FIRE SAFETY INSPECTION REPORT

**CONSUMER KNITEX LIMITED (CMT
BANGLADESH)
DHAMSUR, BHALUKA, MYMENSINGH 2240**

ACCORD
on Fire and Building Safety in Bangladesh

May 10, 2014

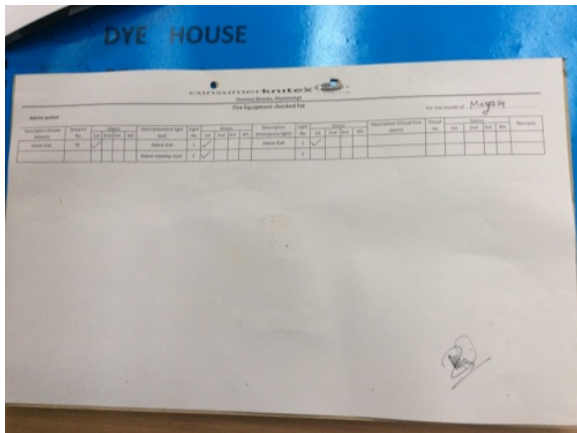
No.	Category	Finding	Recommendation	Remediation Timeframe
F-1	Fire Rated Construction	Areas used for combustible storage at the west and central areas of the factory floor are not separated by fire-rated construction.	Provide dedicated storage rooms separated by minimum 1-hr fire-rated construction. Where separate storage rooms are not feasible, provide defined storage areas and limit the storage arrangement as follows: - Maximum height of 2.4m and maximum area of 23m² - If sprinkler protected: maximum height of 3.66m and maximum area of 93m² Separate areas of unenclosed combustible storage by a minimum clear distance of 3m.	Within 3 months

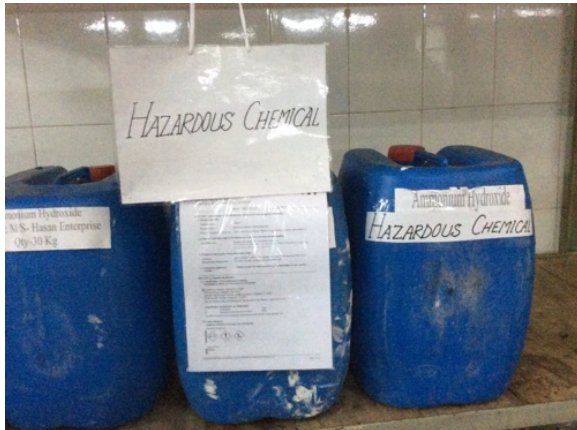
No.	Category	Finding	Recommendation	Remediation Timeframe
F-1	Fire Rated Construction	Hazardous materials storage area is not separated by fire-rated construction. Corrosive materials were store at the middle of the factory floor without fire-rated separations.	Separate the hazardous materials room per BNBC Part 3 Section 2.1.13.	Within 3 months

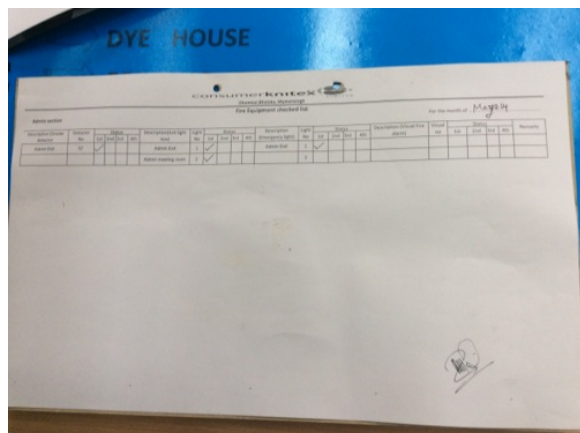
F-4	Fire Protection	Inspection, testing, and maintenance for the fire alarm system was not in accordance with NFPA 72.	Inspect, test and maintain the fire alarm system, and keep written records on-site, in accordance with NFPA 72.	Within 3 months
-----	-----------------	--	---	-----------------

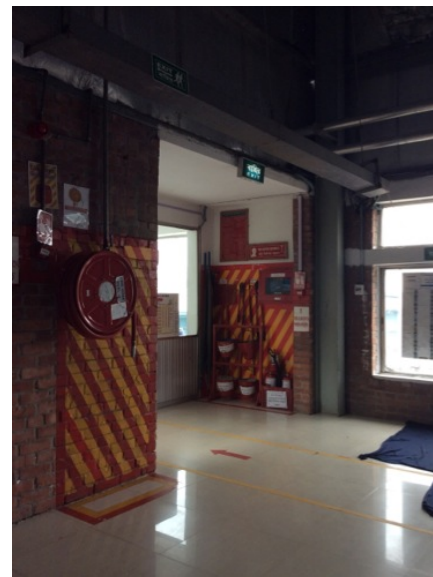
No.	Category	Finding	Recommendation	Remediation Timeframe
F-1	Fire Rated Construction	The exit stairs are not separated from work areas, on each floor by fire-rated construction.	Provide minimum 1.5-hr fire rated doors and seal all unprotected openings to separate the exit stairs from work areas and other building spaces on all floor levels. Ensure that the fire doors are self-closing and positive latching and that they are provided with fire exit (panic) hardware where serving production floors. If fire doors are required to be held open for functional reasons, provide automatic-closing devices tied to the fire alarm system.	Within 3 months

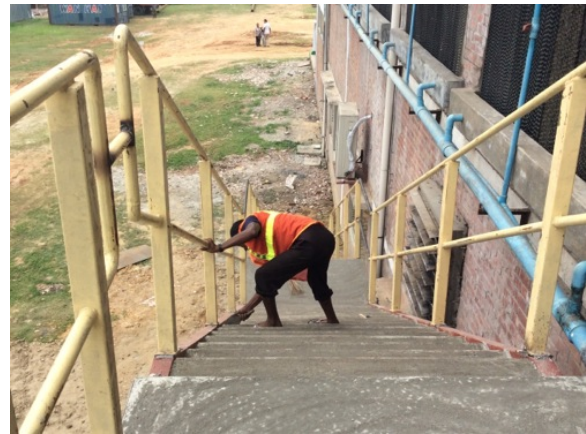
F-3	Egress	Exit capacity is not adequate for the occupant load. 1st floor has an exit capacity of 600 occupants with an actual occupant load of 805.	Reduce occupant load to not more than available exit capacity of 600 occupants and in the future provide an additional emergency exit on the northwest part of the building.	Immediate
-----	--------	---	---	-----------

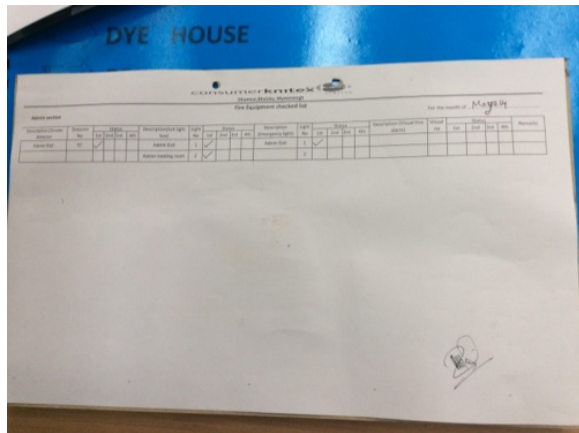
F-6	Fire Protection	Inspection, testing, and maintenance for the fire alarm system was not in accordance with NFPA 72.	Inspect, test and maintain the fire alarm system, and keep written records on-site, in accordance with NFPA 72.	Within 3 months
-----	-----------------	--	---	-----------------
